Title of Change:	NCV8412-D Datasheet Update	
Effective date:	13 Jan 2021	
Contact information:	Contact your local ON Semiconductor Sales Office or Jana.Kubincova@onsemi.com	
Type of notification:	This Product Bulletin is for notification purposes only. ON Semiconductor will proceed with implementation of this change upon publication of this Product Bulletin.	
Change Category:	Change Category - other	
Change Sub-Category(s):	Datasheet/Product Doc change	
Sites Affected:		
ON Semiconductor Sites	External Foundry/Subcon Sites	
None	None	
Description and Purpose:		
<p>In the Maximum Ratings table, parameters Total Power Dissipation and Thermal Resistance were changed. The Typical curves regarding the thermal resistances were also changed – Figure 21. and Figure 23. (previously Figure 22.).</p> <p>The reason for the change is that at the initial release only the faster and therefore less accurate simulations were used to be able to release the product within the required timeframe. Since then, the more detailed and more accurate simulations were completed, so these results should be more closely represent the device’s true behaviour.</p> <p>Removing the Junction-to-Case (Top) because th

Figure 21. $R_{\theta JA}$ vs. Copper Area – SOT-223

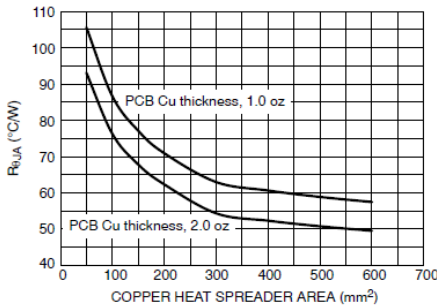
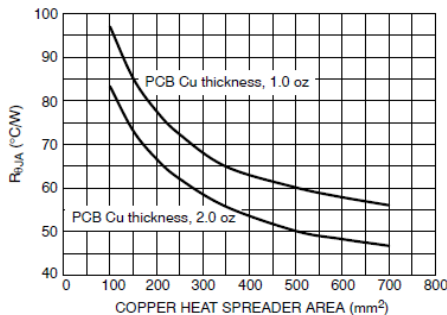
Added Figure 22. $R_{\theta JA}$ vs. Copper Area – SOIC-8 Dual and updated Figure 21. $R_{\theta JA}$ vs. Copper Area – SOT-223 on page 8.

Figure 23. Transient Thermal Resistance – SOT-223

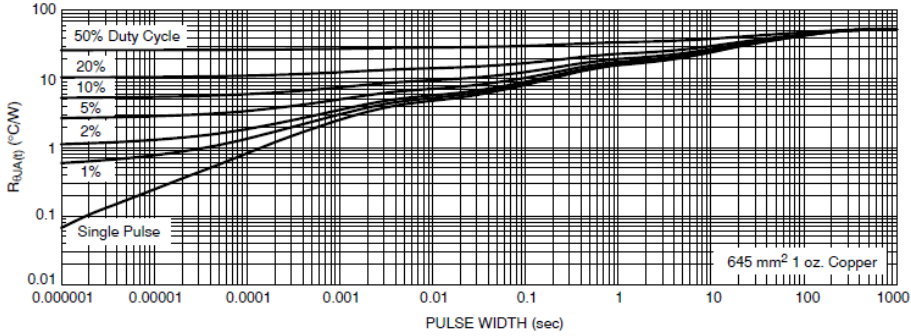
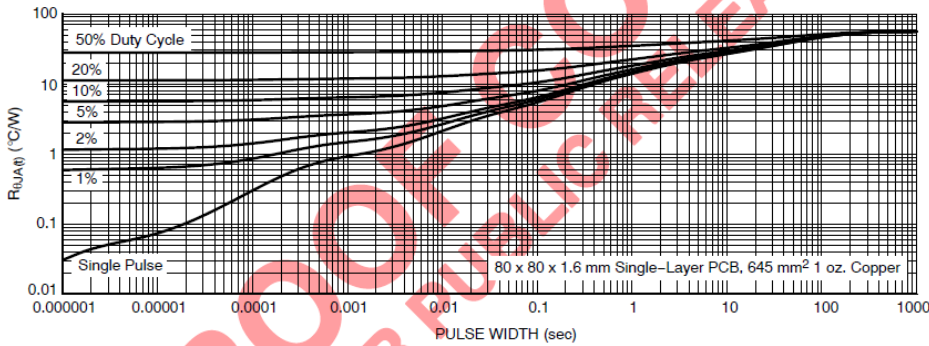
Update of Figure 23 - Transient Thermal Resistance – SOT-223 on page 8
Current datasheet

Figure 24. Transient Thermal Resistance – SOIC-8 Dual, only 1 channel loaded

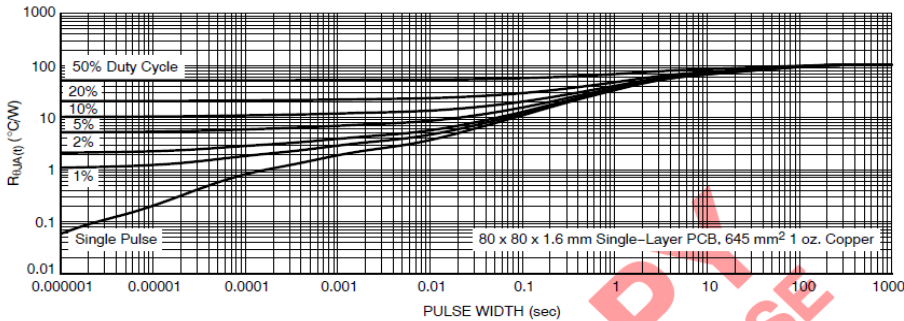
Added Figure 24. Transient Thermal Resistance – SOIC-8 Dual, only 1 channel loaded and Figure 25. Transient Thermal Resistance – SOIC-8 Dual, both channels loaded equally on page 9.
